SADDLEHORN RANCH
 OVERALL WATER SYSTEM
 ALTERNATIVE LANDSCAPE PLAN

C16
 SHEET 16 OF ---

PCD File No. PPR-21-

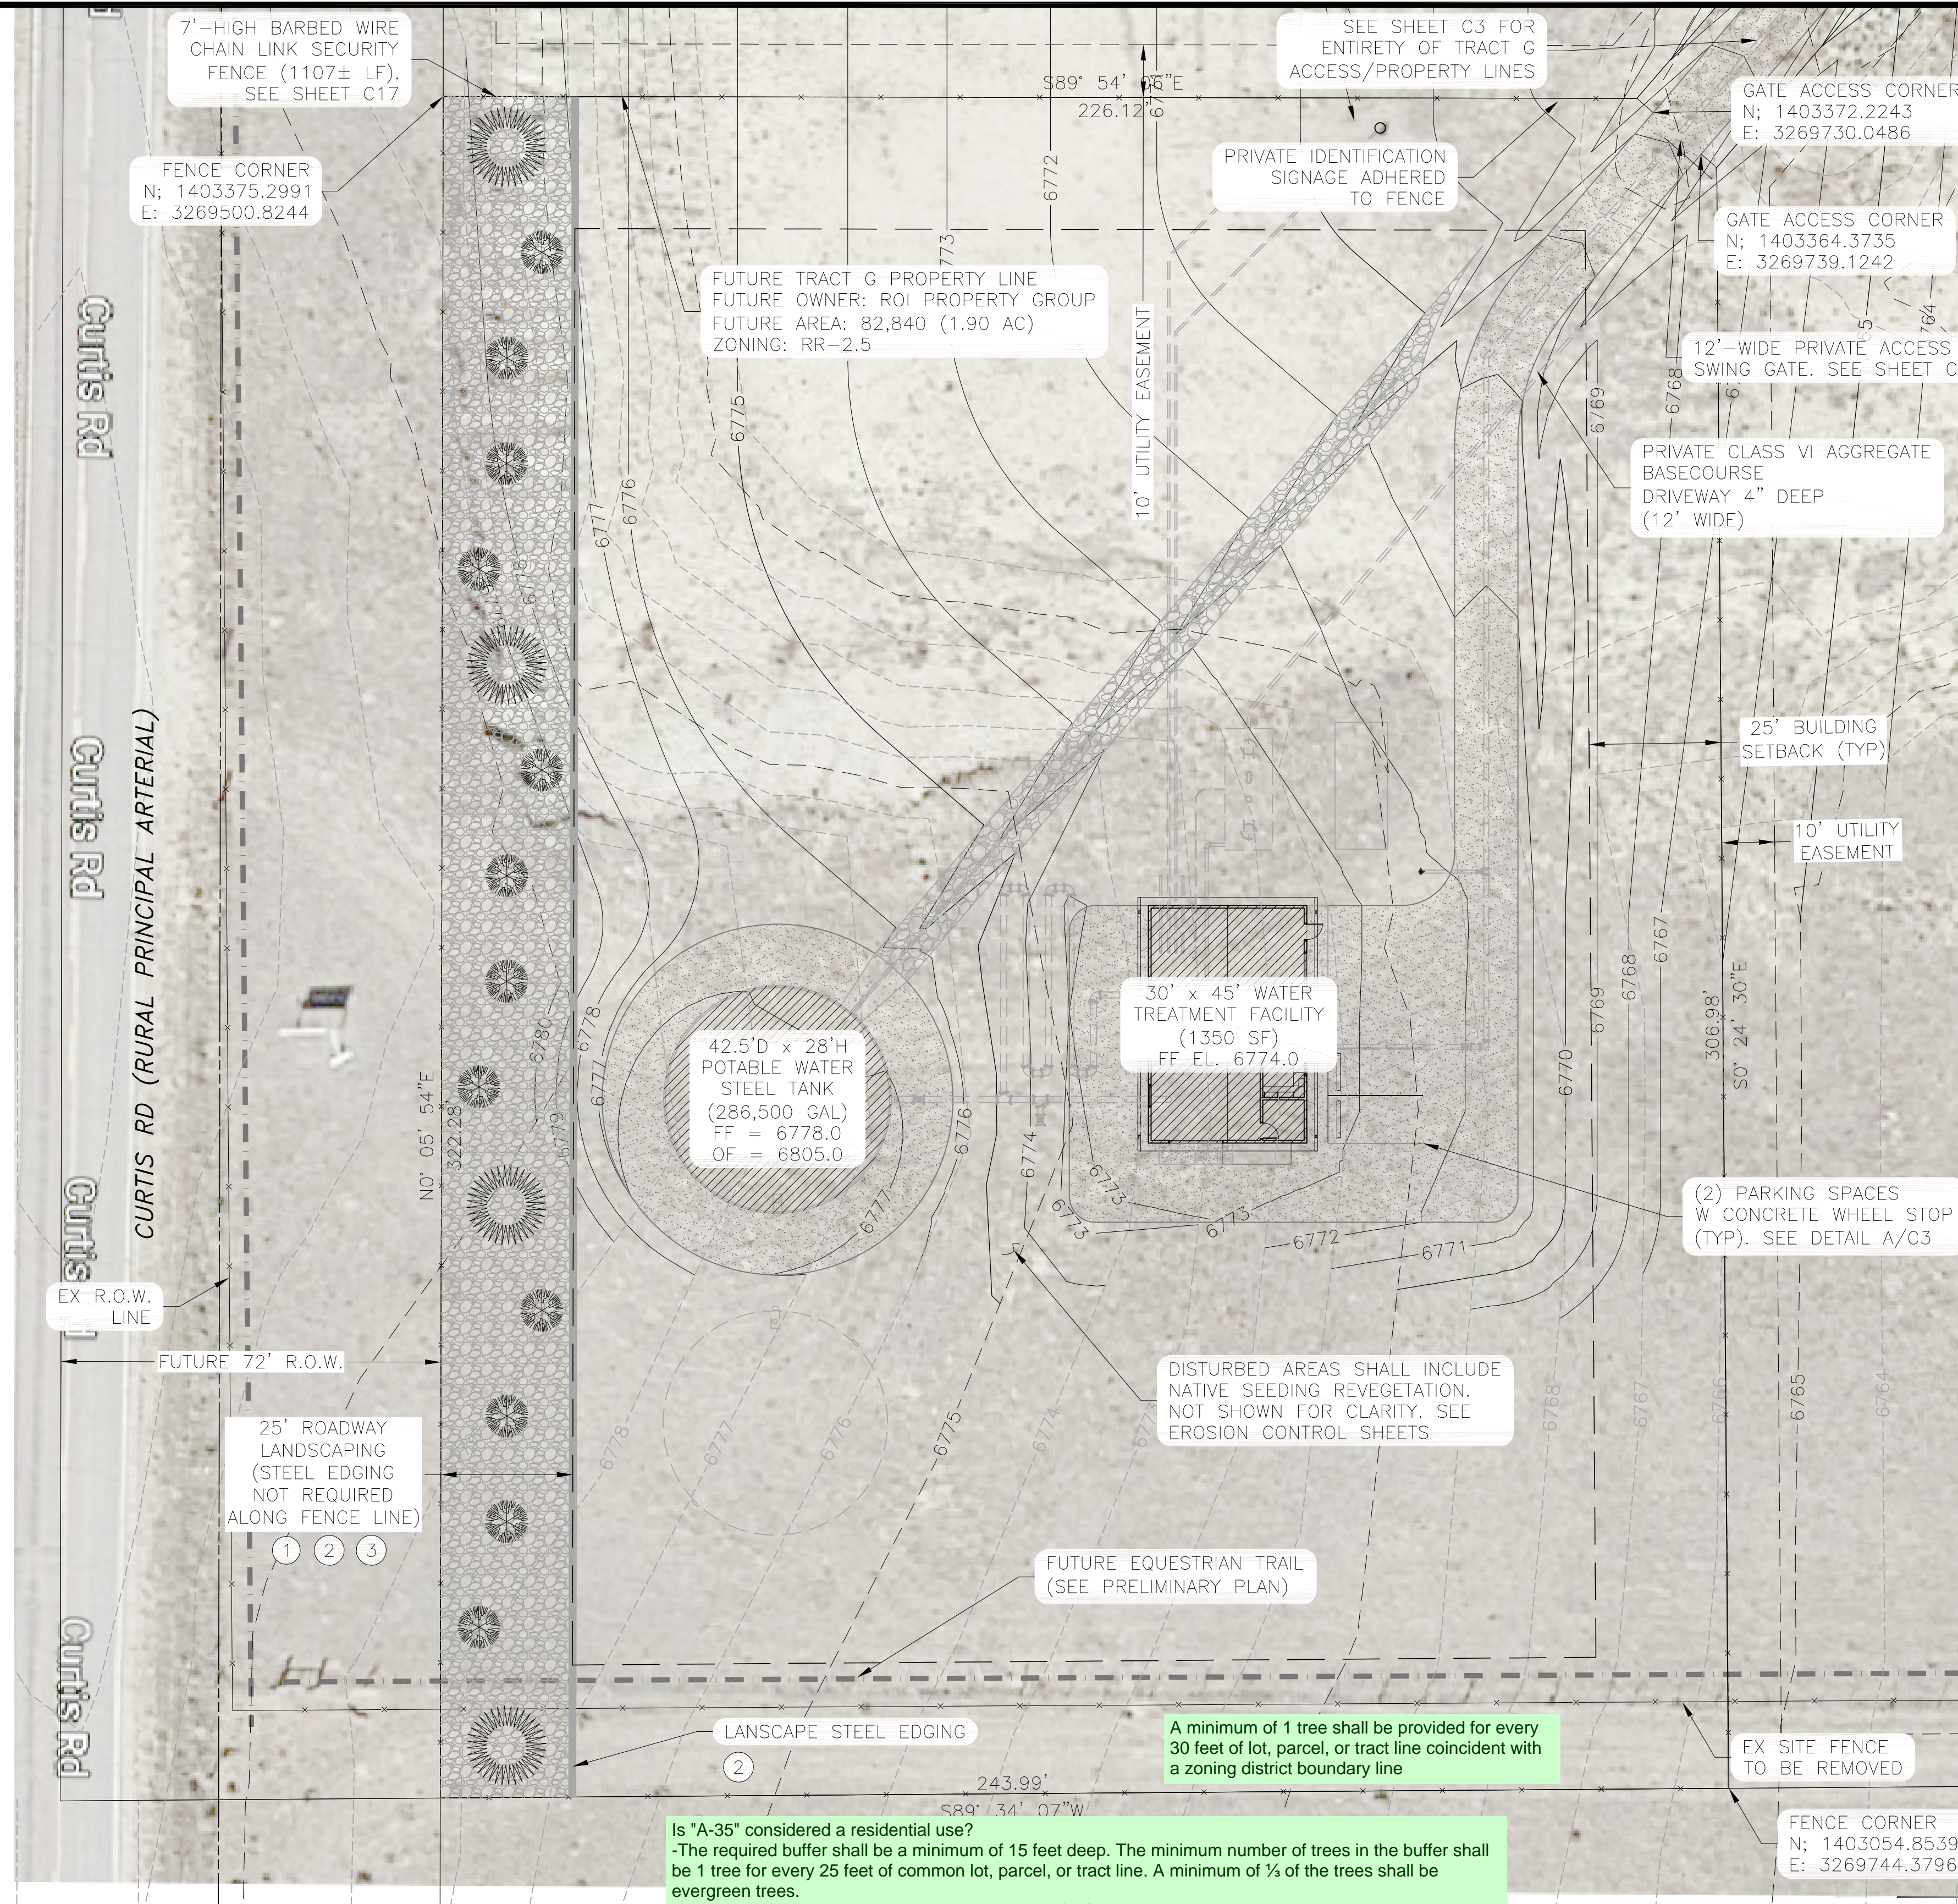
A minimum of 5% of the lot or parcel shall be landscaped. Please show that this requirement is being met on the table by tabulating total landscaped area.

Is "A-35" considered a residential use?
 -The required buffer shall be a minimum of 15 feet deep. The minimum number of trees in the buffer shall be 1 tree for every 25 feet of common lot, parcel, or tract line. A minimum of 1/3 of the trees shall be evergreen trees.
 -An opaque fence or wall with a minimum height of 6 feet is required
